DEVELOPMENT APPLICATION ASSESSMENT REPORT

Application Number:	DA2021/0900
----------------------------	-------------

Responsible Officer:	Gareth David
Land to be developed (Address):	Lot 151 DP 6937, 40 Sunrise Road PALM BEACH NSW 2108
Proposed Development:	Construction of a dwelling house including a swimming pool and spa
Zoning:	C4 Environmental Living
Development Permissible:	Yes
Existing Use Rights:	No
Consent Authority:	Northern Beaches Council
Delegation Level:	DDP
Land and Environment Court Action:	No
Owner:	Susan Elizabeth Rothwell
Applicant:	Susan Rothwell Architects

Figure 1: 3D representation of the proposed building form relative to the 8.5m building height with areas above 8.5m highlighted in red

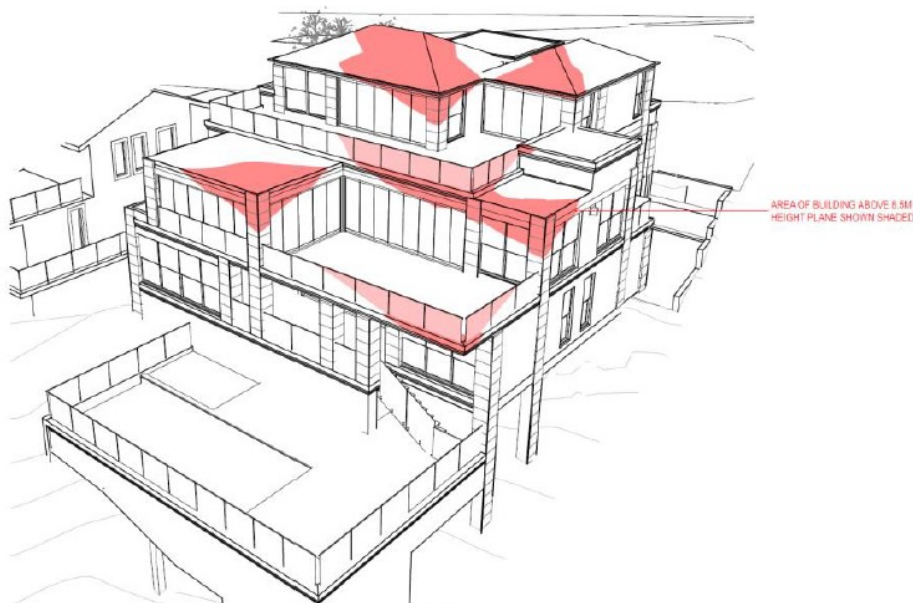
The variation to the 8.5m height limit is demonstrated in Figure 1 below. As shown, the extent of the variation is predominantly limited to the roof form and areas of open balustrading. The non-compliances generally occur as the land falls away steeply to the north and the west. The exceedances of the 8.5m is considered to be minor.

Figure 1: View angles over the subject site

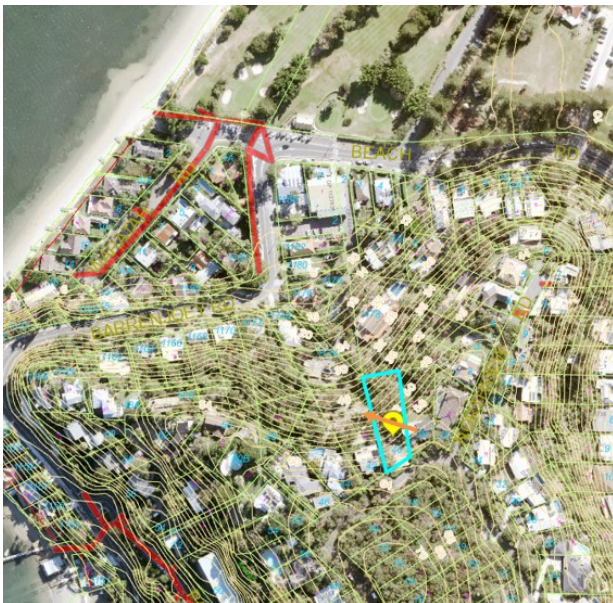
Figure 1 below shows the origin of the submissions relative to the subject site, and the view angles of the sites over the subject site (outlined in blue).

Figure 1: Envelope breach on the eastern elevation shown in green

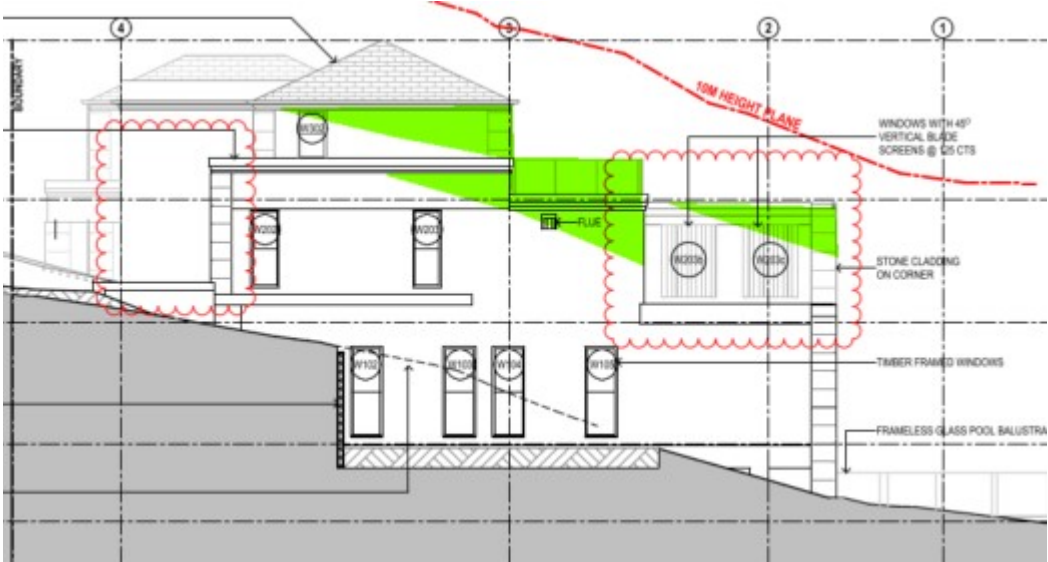
The proposed development encroaches into the prescribed building envelope along both the eastern and western elevation. This variation is represented in figures 1 and 2 below.

This building envelope non-compliance is largely attributed to the slope of the site, which exceeds 30%. P21DCP allows for a variation to the prescribed building envelope for development on steep sites, subject to consistency with the outcomes of this Clause. Furthermore, amended plans were received during the assessment of this application which reduced the side boundary envelope non-compliance on both side elevations by reducing the overall height of the dwelling and increasing side setbacks.
